UNITED STATES PATENT AND TRADEMARK OFFICE

APPLICATION NO.	FILING DATE	FIRST NAMED INVENTOR	ATTORNEY DOCKET NO.	CONFIRMATION NO.
10/796,938	03/09/2004	Ron Naftali	6317P024	4473

Office Action Summary	Application No. 10/796,938	Applicant(s) NAFTALI, RON	
	Examiner Michael Liu	Art Unit 2882

DETAILED ACTION

FIG. 3

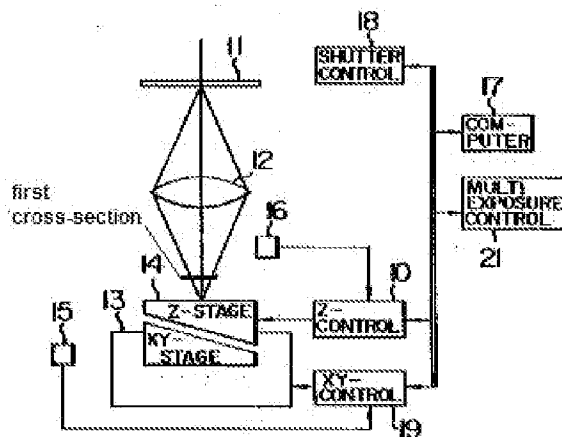
Claims 1, 5: Fukuda discloses a method (Fig 3) for recording a pattern (11), comprising:

determining an illumination scheme (by 21) in response to the pattern; and
directing, in response to the determination, at least one focused (C14L11-12) beam of radiation (C11L62-63: excimer laser) having a first cross-section (Drawing 1) onto an intermediate layer (44) (Fig 8c), said intermediate layer comprising a reversible transmission film (44), said reversible transmission film configured to allow only a portion of said beam, said portion having a second cross-section (Fig 8d: grooves between 46), to propagate towards a radiation sensitive layer (42), said second cross-section being smaller than the first cross-section.

Drawing 1 Fig 3 with first cross-section labeled.

Claims 3, 7: Fukuda discloses wherein the second cross-section (Fig 8d) is about half of the first cross-section (Drawing 1).
